JRPP No:	2011SYE078
DA No:	DA 291/11
PROPOSED DEVELOPMENT:	156-158 Pacific Highway, Crows Nest Demolition of the existing building and erection of a 10 storey mixed use building containing 404m ² of retail floor space, 40 residential apartments and three levels of basement carparking for 31 vehicles.
APPLICANT:	LJB Urban Planning Pty Ltd
REPORT BY:	George Youhanna, Executive Planner, North Sydney Council

Assessment Report and Recommendation

East elevation of proposal (Pacific Highway)

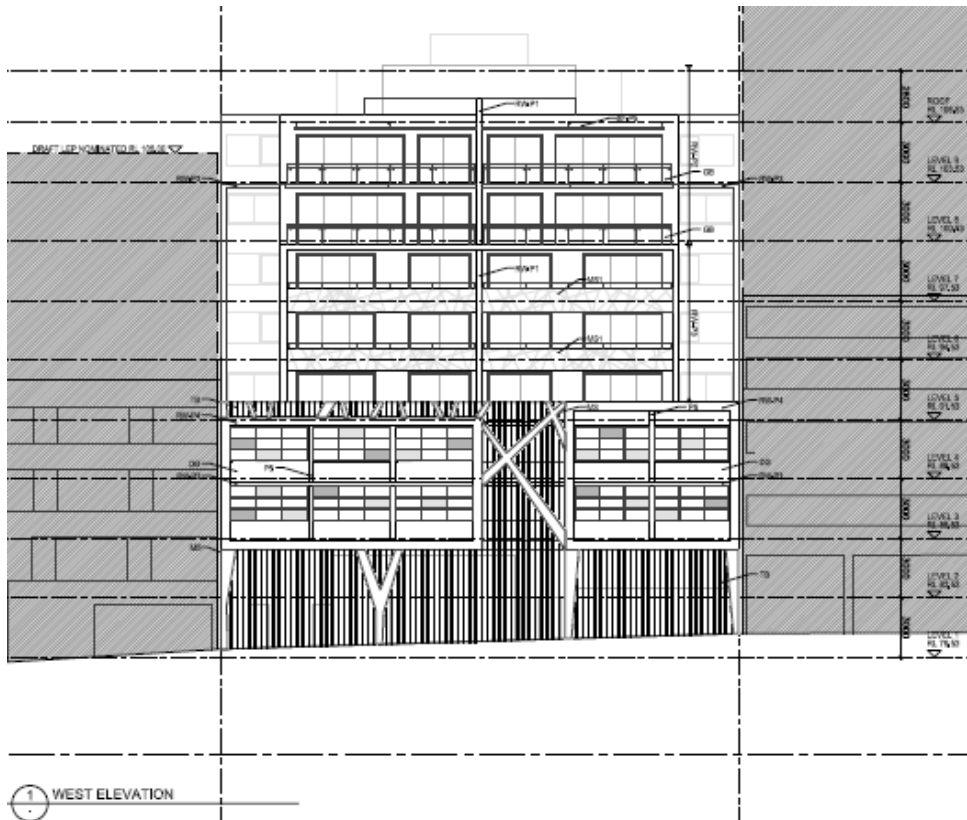
- 2. The front elevation, plans and photomontage do not entirely correlate and require further refinement to do so. Additionally, the form of the façade does not follow the internal function of the building in relation to the bedroom and balcony uses and the selection of window and balcony enclosures. It is recommended that there is an appropriate relationship between the internal planning requirements and the external expression of the building.*

12. *In response to the panels comments, the Pacific Hwy design has been refined as follows:*

The amended plans have largely addressed the DEP's concerns by providing additional details of the louvre and screen façade treatment, amending the internal room function to more appropriately correlate with the façade expression, refining the architectural treatment of the upper levels of the building and the rear façade, and improving acoustic amenity between the windows of adjoining units facing the light wells. The photomontage also depicts patterned metal screens in front of a number of balcony balustrades on Levels 2-8 on the Pacific Highway elevation and at Levels 6 and 7 on the Doohat Lane elevation. It is considered that the metal screens in front of the balustrades are unnecessary and do not enhance the façade design. The patterned metal balustrade screens to both elevations should be replaced with either translucent glazing or masonry balustrades, matching the proposed colour palette.

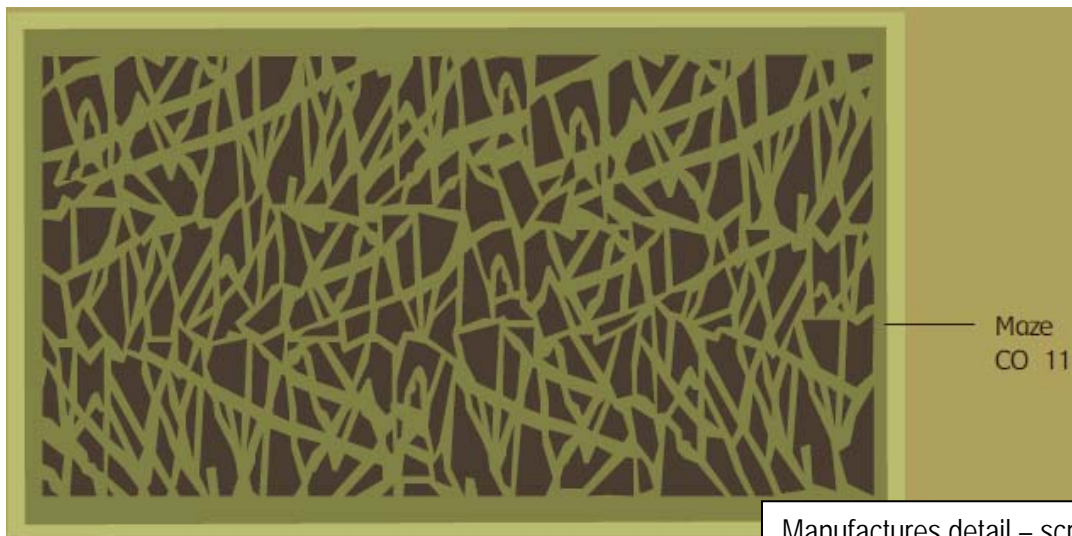
1. *The panels raised concern with the bedrooms on levels 4 & 5 (to units 16 & 21) having operable louvers.*
2. *In response small balconies connecting to the main balcony have been added to the bedrooms. The balconies enable a continuation of the glass louvers at the facade which is an integral part of the building's design. By the introduction*

5. *In addition, the panel had concerns with the perforated metal screen and the double layer combined with the louvers behind and whether this resulted in the units being too enclosed. The panel questioned whether the screen was necessary.*

of the balconies, the units are setback from the main facade and can control ventilation and acoustic amenity through opening and closing their bedroom window.

3. *It is considered that this is an appropriate design response as it enables a balance between internal amenity and the integrity of the facade.*

4. *As a result of the addition of the small balconies the internal area of the units has been reduced and a minor re-configuration of units 16, 21 & 23.*
